ADDENDUM NO. 1

Date March 28, 2017

**Project: Irrigation Improvements & Outdoor Learning Area
at A.M. Winn K-8 School**

AD1-1

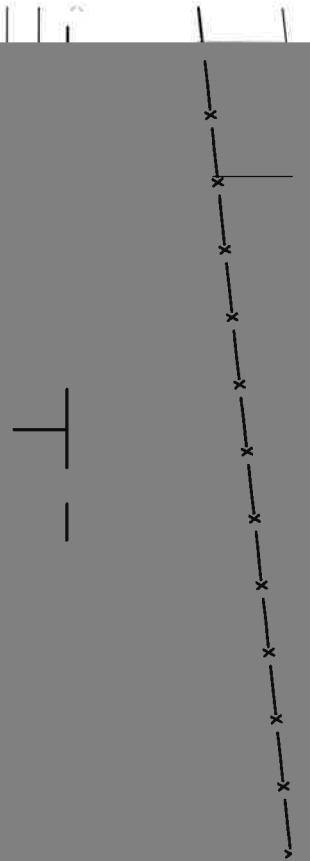
1. DRAWINGS –L1.1

These dematerials can be removed from the scope. The school district has already

DEMO CONCRETE AND FENCE FOR
EXISTING PUMP/CONTROLLER YARD

EXISTING ELECTRIC IRRIGATION
CONTROLLER TO BE REMOVED
AND REPLACED BY SPLICE BOX,
SEE IRRIGATION SHEET L2.1

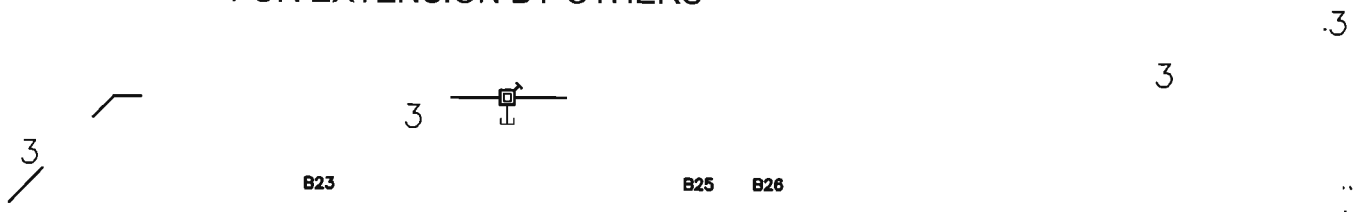
VALVES IN THIS AREA ARE TO BE
INSTALLED AND LATERAL LINE CAPPED
FOR EXTENSION BY OTHERS

ELECTRICAL WIRES FROM DEMOLISHED
IRRIGATION CONTROLLER TO BE PLACED

IN NEW SPLICE BOX AND CONNECTED TO
NEAREST NEW IRRIGATION MAINLINE
